Building Review (paul.skidmore)

PROJECT: BOYLE RESIDENCE
DRAWING TITLE: MERCER ISLAND, WA
GENERAL NOTES

SHEET NO. S1.1

PROJECT	DATE 07/25/17
DRAWING TITLE	REVISION
PERMIT SET	SHEET NO. S1.1

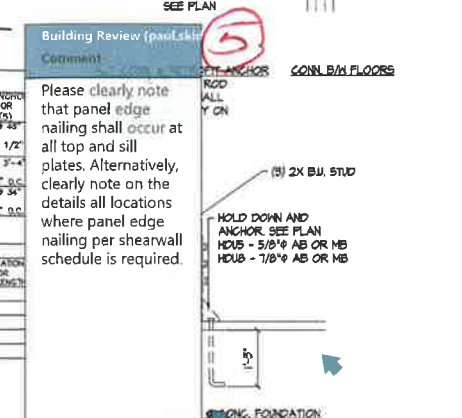
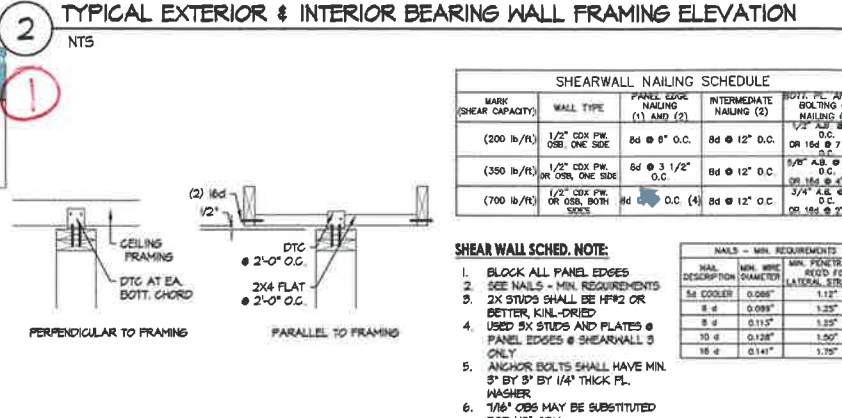
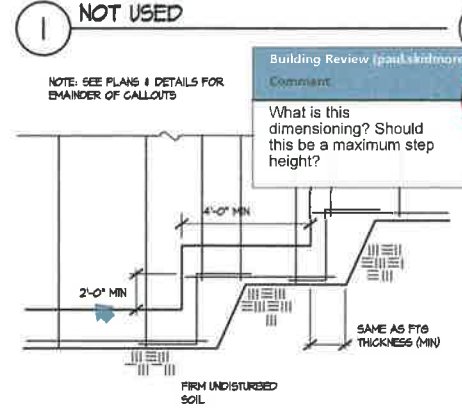
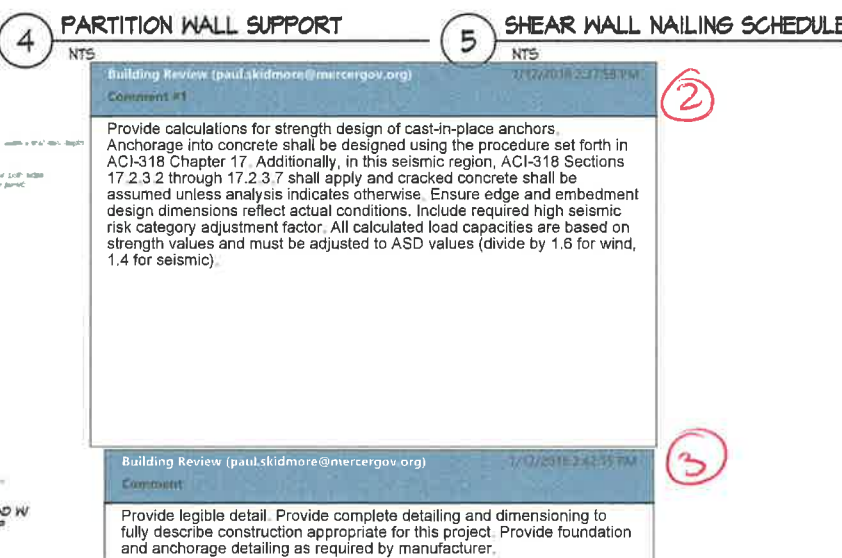
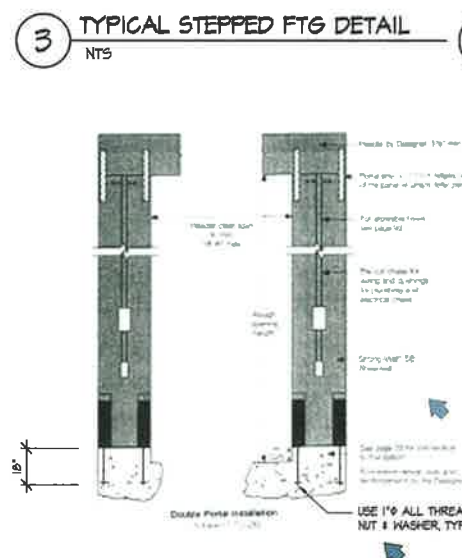
Building Review (paul.skidmore@mercer.gov) Comment #1: Provide calculations for strength design of cast-in-place anchors. Anchorage into concrete must be designed using the procedure set forth in ACI-318 Appendix D. Headed bolts or headed studs cast in concrete must be evaluated using Strength Design as specified in this section. Additionally, in this seismic region, ACI-318 Sections D3.3.1 through D3.3.5 shall apply and cracked concrete shall be assumed unless analysis indicates otherwise. Ensure edge and embedment design dimensions reflect actual conditions. Include required high seismic risk category adjustment factor. All calculated load capacities are based on strength values and must be adjusted to ASD values (divide by 1.6 for wind, 1.4 for seismic).

PROJECT	BOYLE RESIDENCE
DRAWING TITLE	FOUNDATION & FIRST FLOOR FRAMING PLANS
DATE	07/25/17
REVISION	
SHEET NO.	S2.1

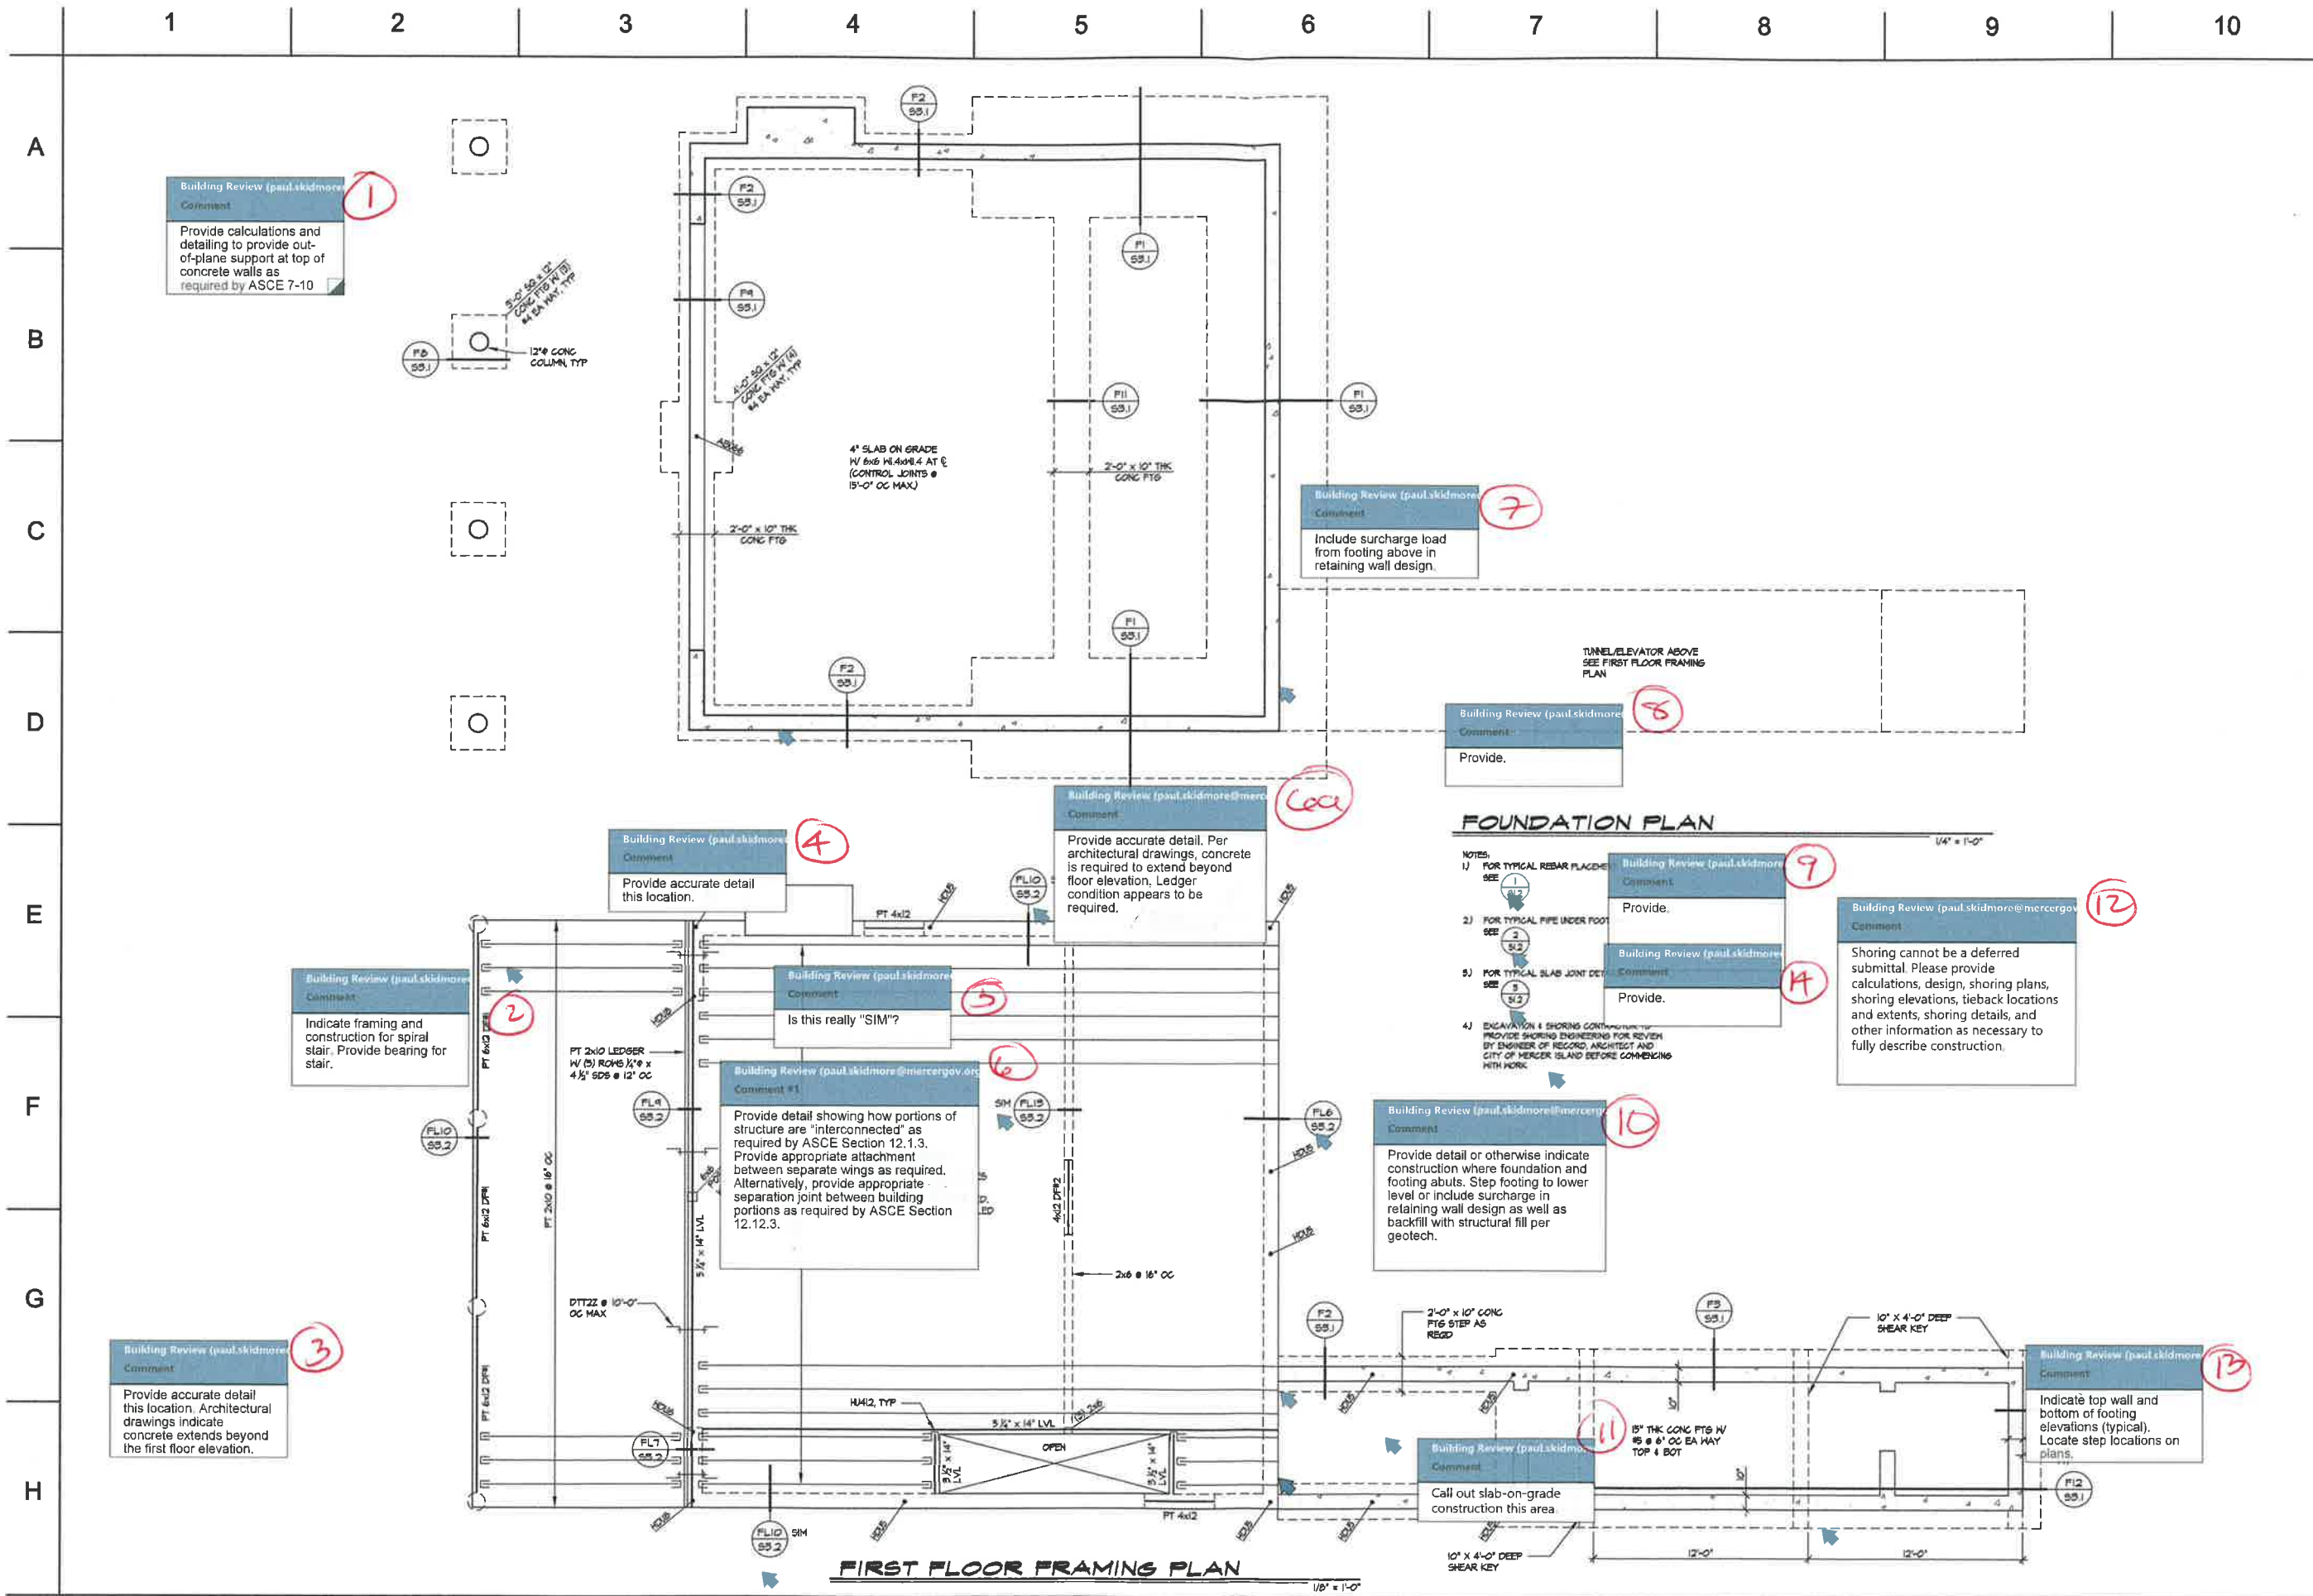
Building Review (paul.skidmore)
 Comment
 Provide calculations and detailing to provide out-of-plane support at top of concrete walls as required by ASCE 7-10

Building Review (paul.skidmore)
 Comment
 Include surcharge load from footing above in retaining wall design.

Building Review (paul.skidmore)
 Comment
 Provide.

Building Review (paul.skidmore@mercergov.org)
 Comment
 Shoring cannot be a deferred submittal. Please provide calculations, design, shoring plans, shoring elevations, tieback locations and extents, shoring details, and other information as necessary to fully describe construction.

Building Review (paul.skidmore@mercergov.org)
 Comment
 Provide detail or otherwise indicate construction where foundation and footing abuts. Step footing to lower level or include surcharge in retaining wall design as well as backfill with structural fill per geotech.

Building Review (paul.skidmore)
 Comment
 Indicate framing and construction for spiral stair. Provide bearing for stair.

Building Review (paul.skidmore)
 Comment
 Provide accurate detail this location.

Building Review (paul.skidmore)
 Comment
 Is this really "SIM"?

Building Review (paul.skidmore@mercergov.org)
 Comment #1
 Provide detail showing how portions of structure are "interconnected" as required by ASCE Section 12.1.3. Provide appropriate attachment between separate wings as required. Alternatively, provide appropriate separation joint between building portions as required by ASCE Section 12.12.3.

Building Review (paul.skidmore)
 Comment
 Provide accurate detail this location. Architectural drawings indicate concrete extends beyond the first floor elevation.

Building Review (paul.skidmore)
 Comment
 Call out slab-on-grade construction this area

Building Review (paul.skidmore)
 Comment
 Indicate top wall and bottom of footing elevations (typical). Locate step locations on plans.

PROJECT: BOYLE RESIDENCE
DRAWING TITLE: GARAGE FOUNDATION & FRAMING PLANS
DATE: 07/25/17
REVISED:
SHEET NO.: **S2.3**

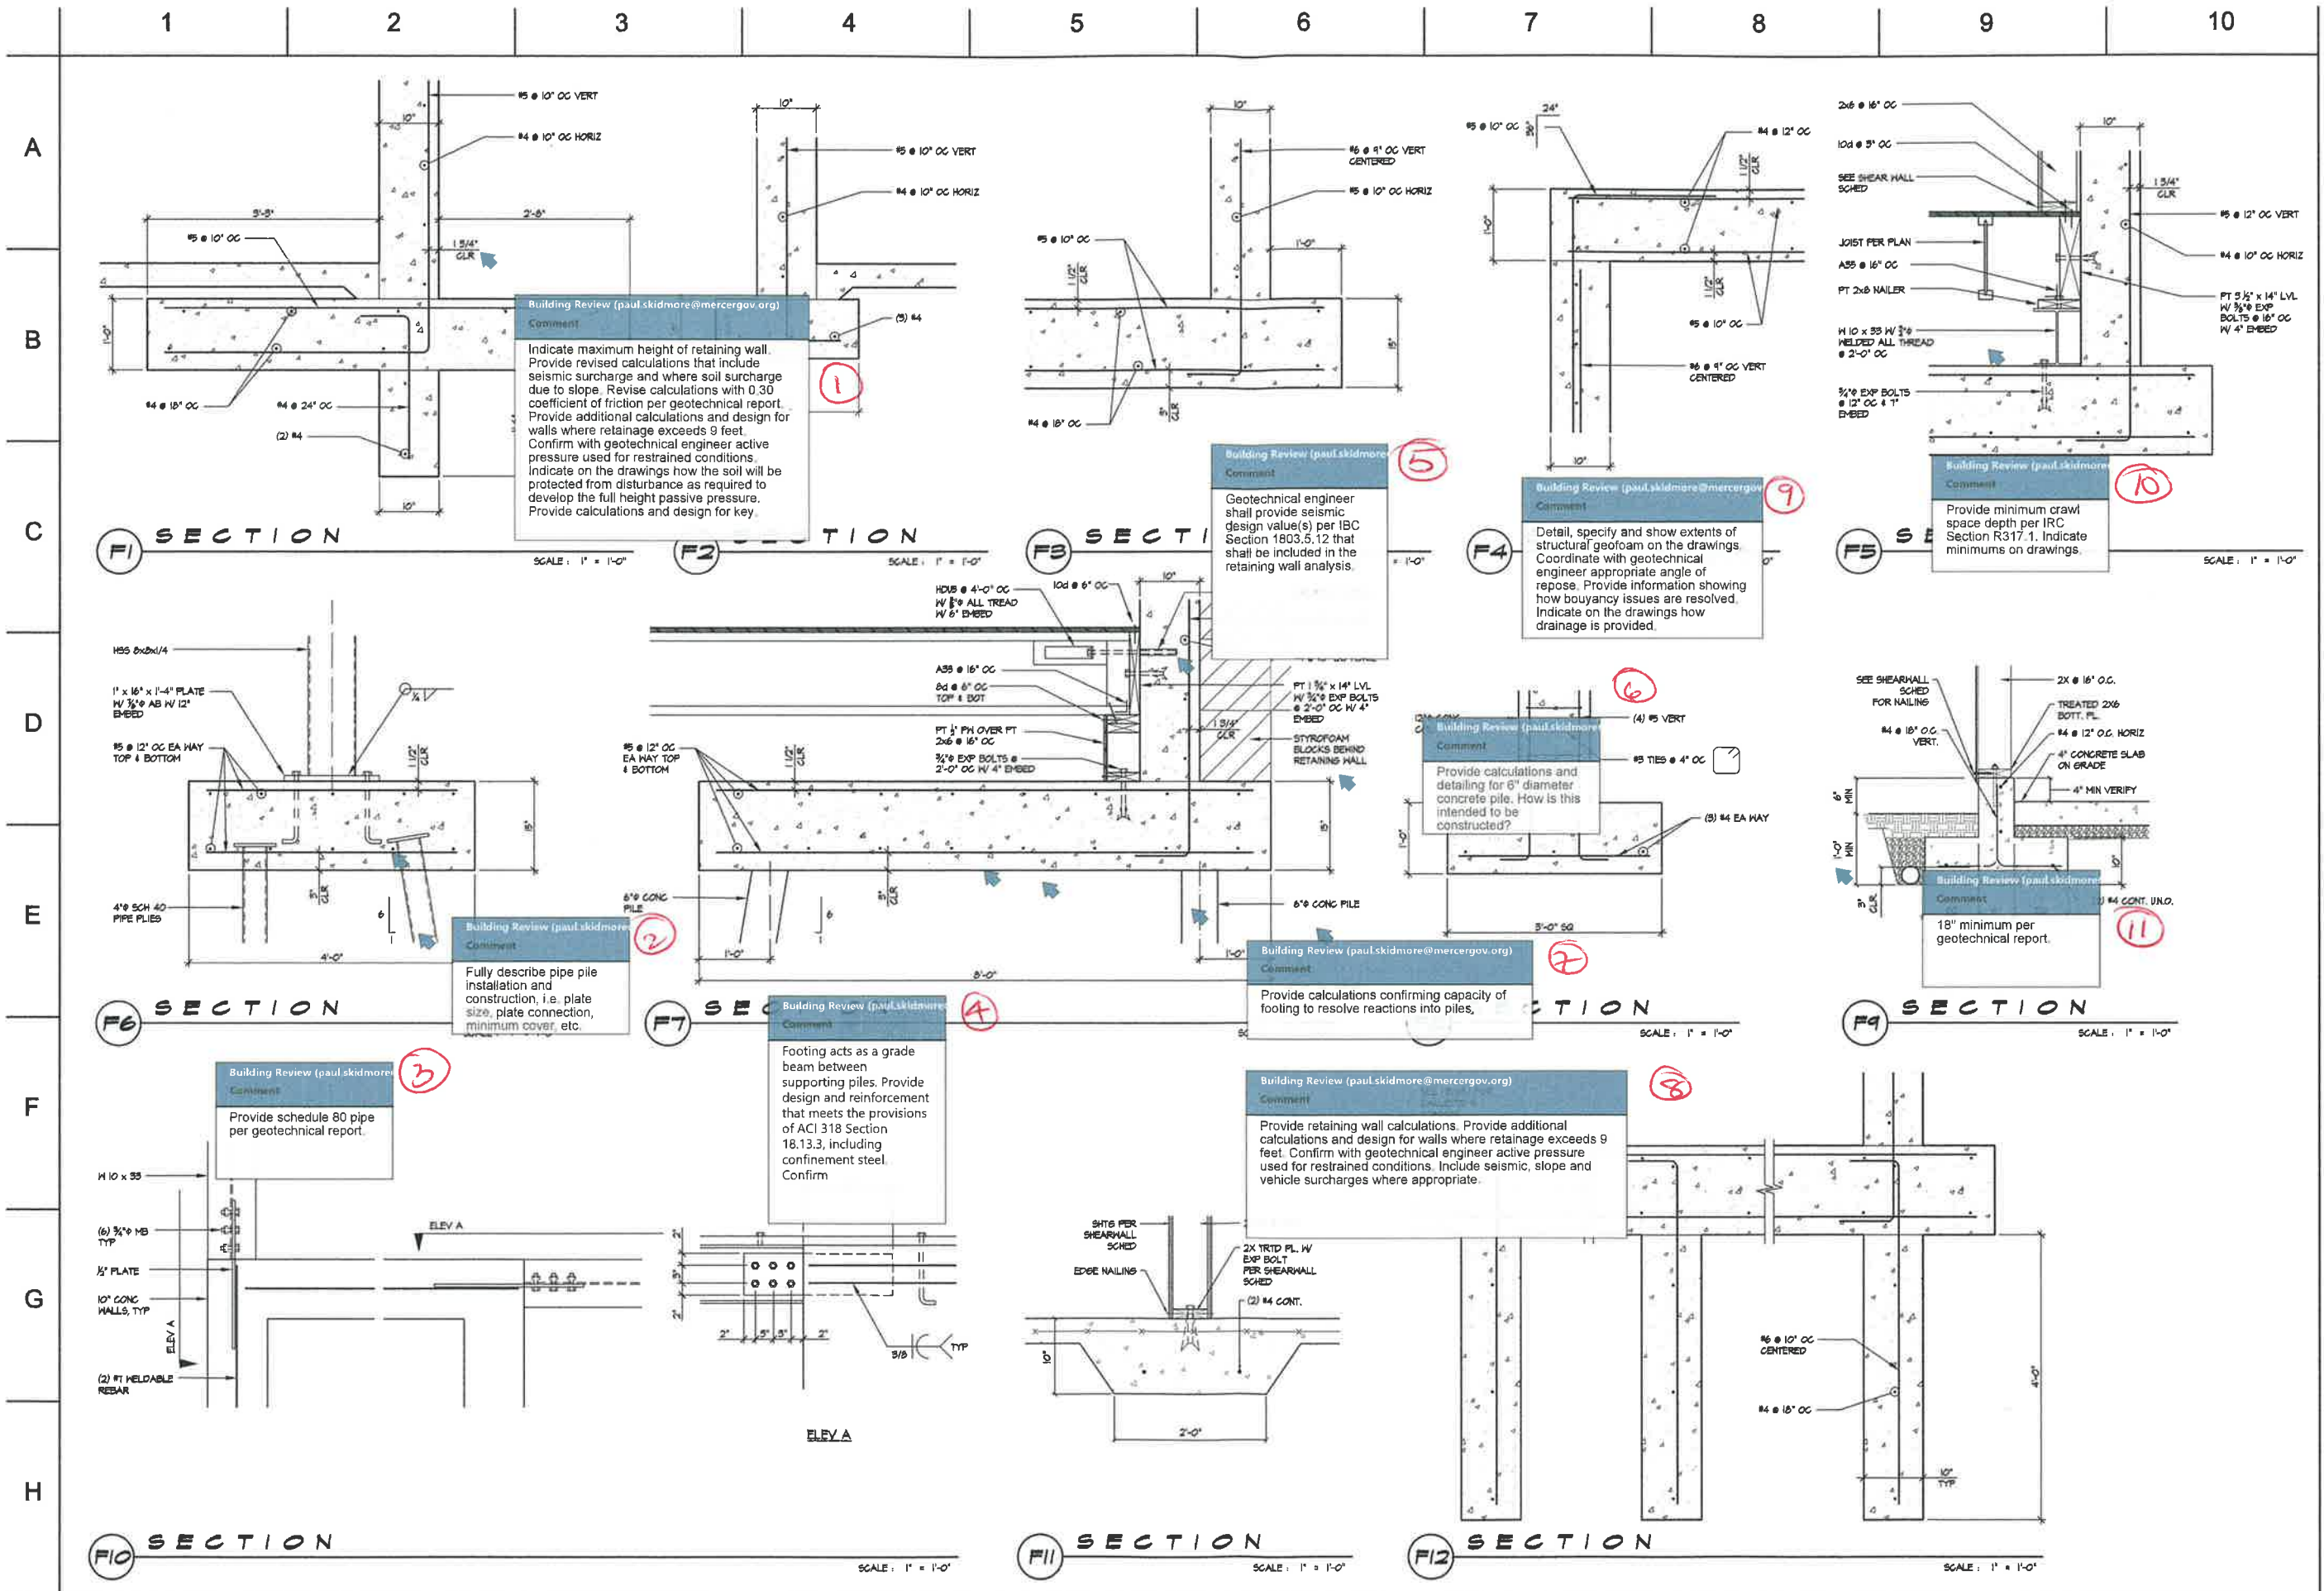
Building Review (paul.skidmore@mercergov.org)
Comment #1
Provide detail showing how portions of structure are "interconnected" as required by ASCE Section 12.1.3. Provide appropriate attachment between separate elements of the structure as required. Alternatively, provide appropriate separation joint between building portions as required by ASCE Section 12.12.3.

Building Review (paul.skidmore@mercergov.org)
Comment
Provide complete structural calculations and detailing for concrete elevator shaft. If intended to resolve lateral forces, provide special reinforced concrete shearwall design per ACI 318 Section

Building Review (paul.skidmore@mercergov.org)
Comment
Provide positive lateral connection for deck to main structure. DTT2Z are noted, but are not capable of developing code required forces.

Building Review (paul.skidmore@mercergov.org)
Comment #1
Provide detail showing how portions of structure are "interconnected" as required by ASCE Section 12.1.3. Provide appropriate attachment between separate wings as required. Alternatively, provide appropriate separation joint between building portions as required by ASCE Section

Building Review (paul.skidmore@mercergov.org)
Comment
Confirm by calculation capacity of ledger to resolve point load from 6x12 beam.

Building Review (paul.skidmore@mercergov.org)
Comment
Provide detail / elevation callout for WSW. Indicate
